Troy Schools District

RFP #2324-15 BP#3A Smith Middle School – Foundations and Steel -Addendum #2 February 7th, 2024

Troy Schools District – BP#3A Smith Middle School – Foundations and Steel

Addendum #1 Bidder Clarifications

DRAWING TITLE **DEMOLITION AND** SESC PLAN

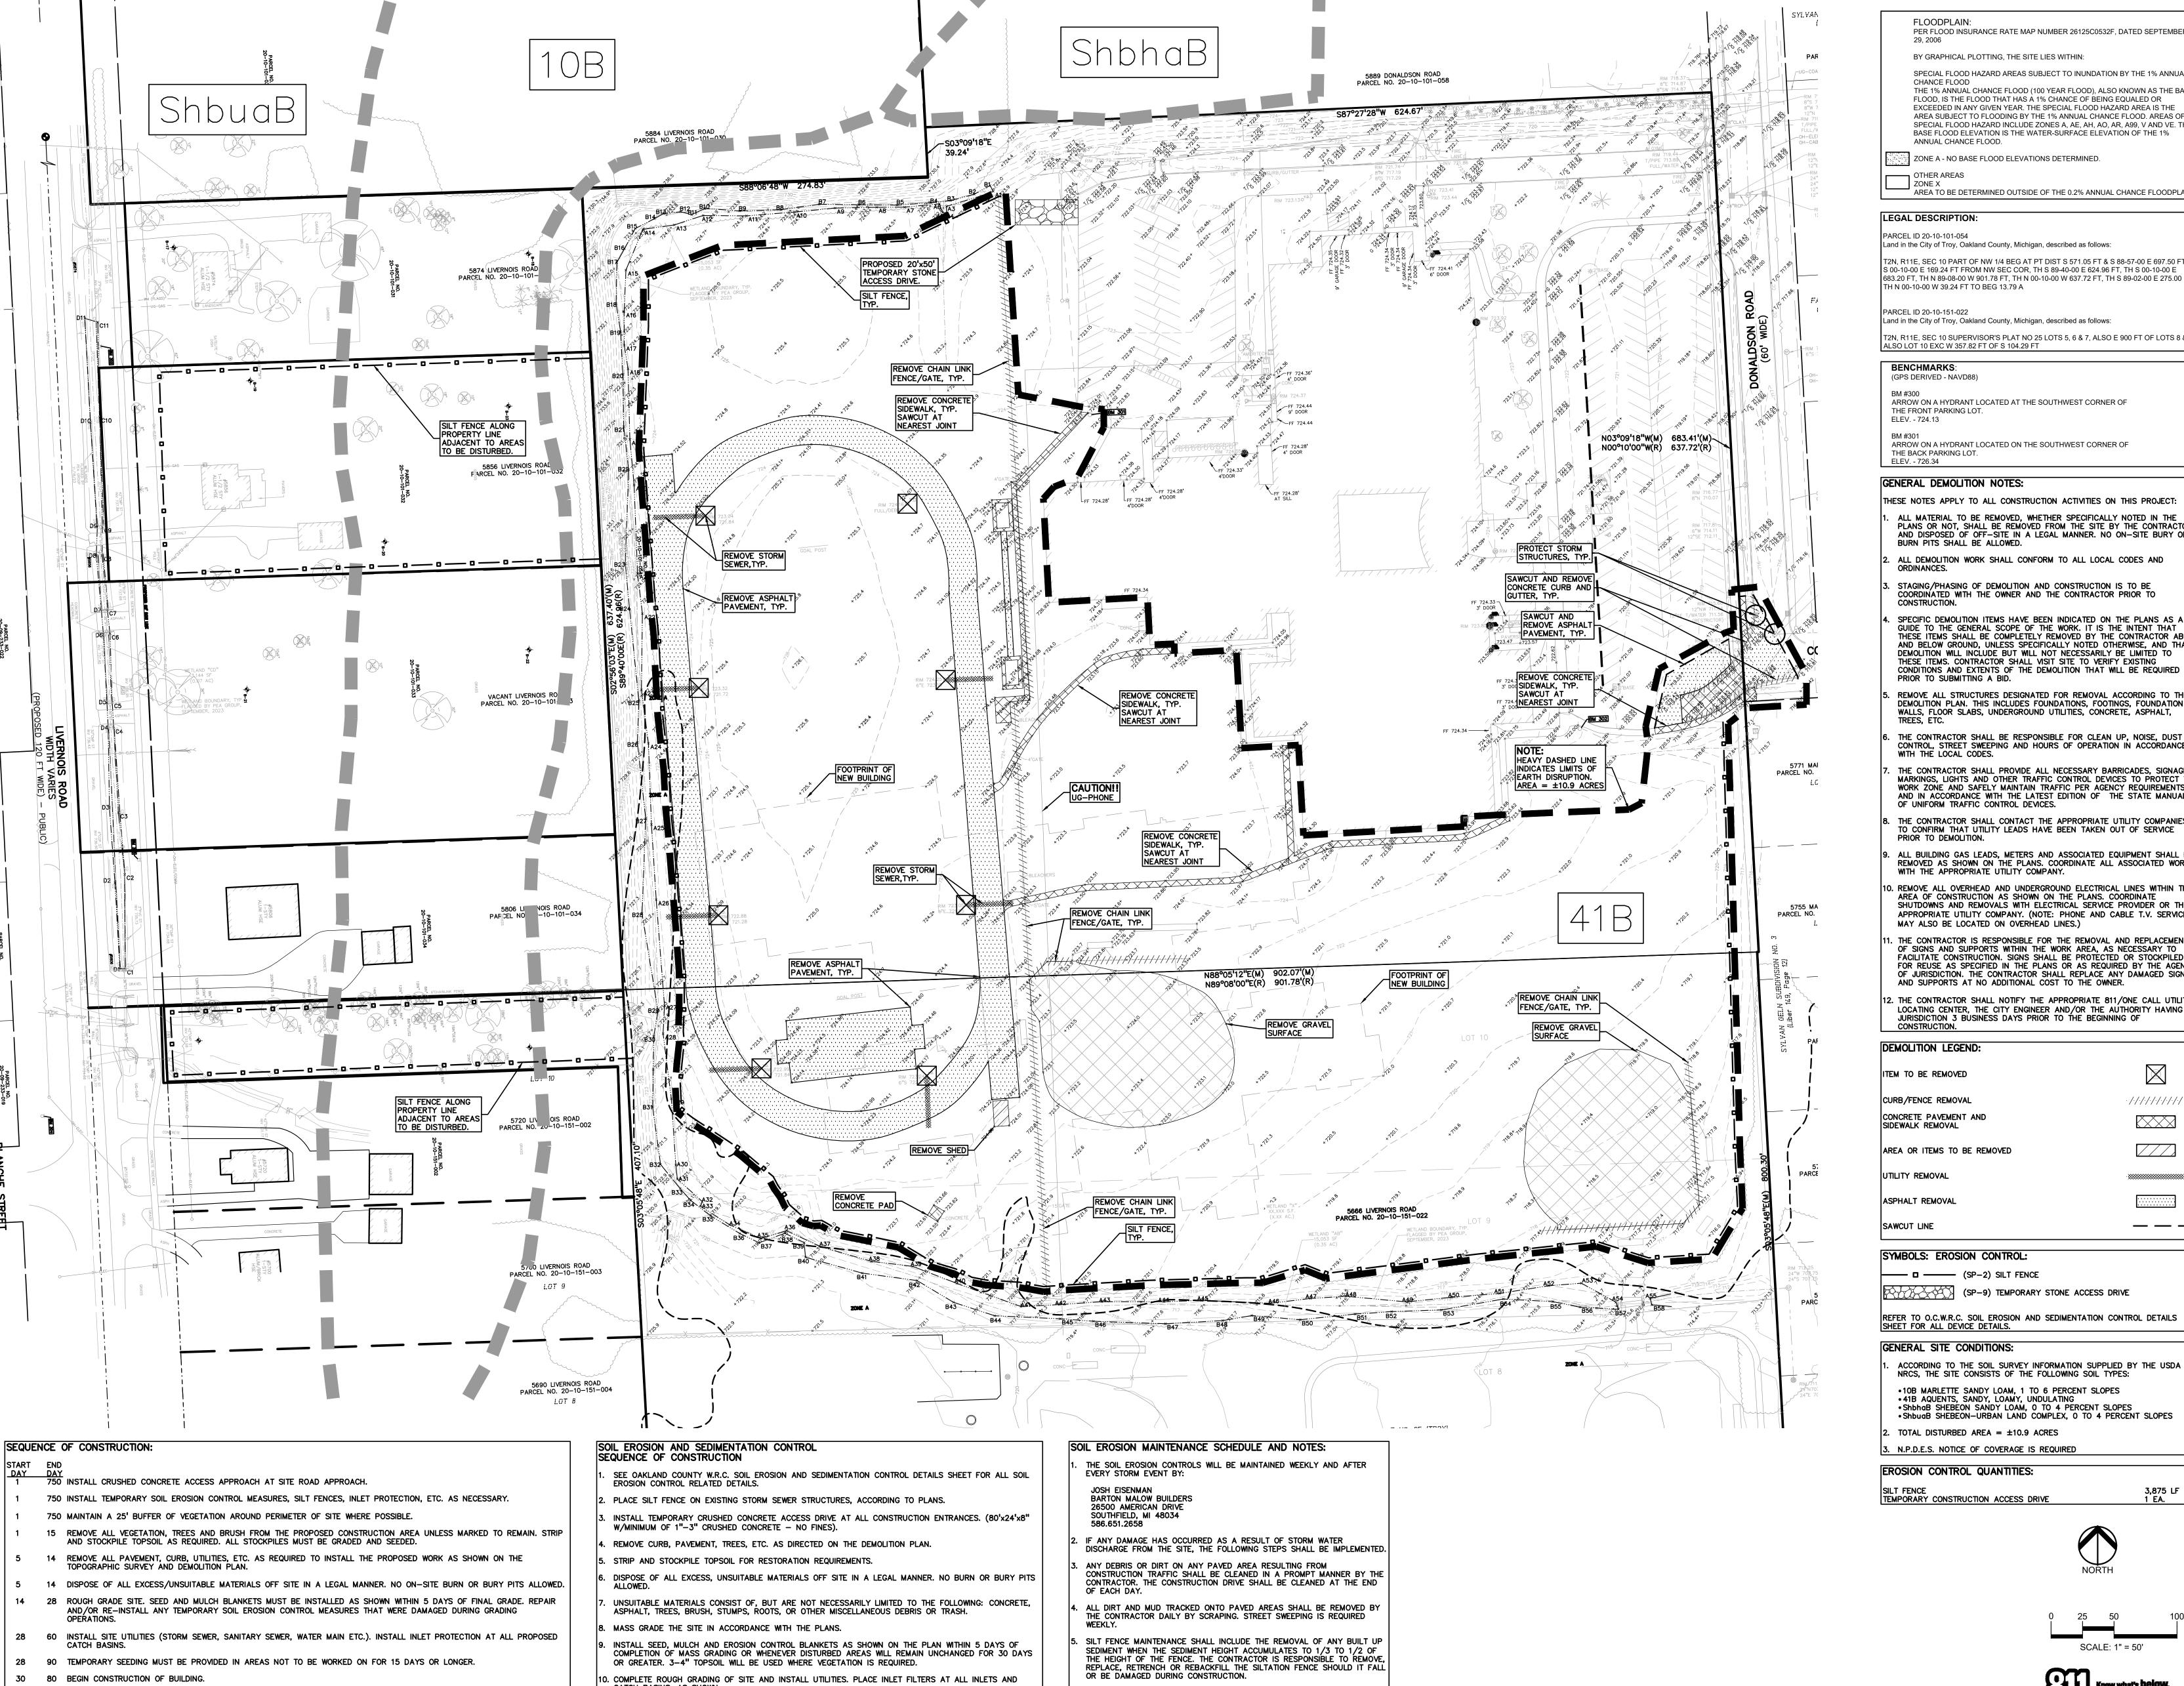
Q: The SESC as denoted on C-2.0 does not encompass the full location of the new building, leaving excavation outside the bounds of the SESC. Specifically, the Southeast corner of the SESC plan.

Q: Please include a plan showing the existing grades of the site under the building.

A: A revised C-2.0 is issued as a part of this addendum.

A: A revised C-2.0 is issued as a part of this addendum.
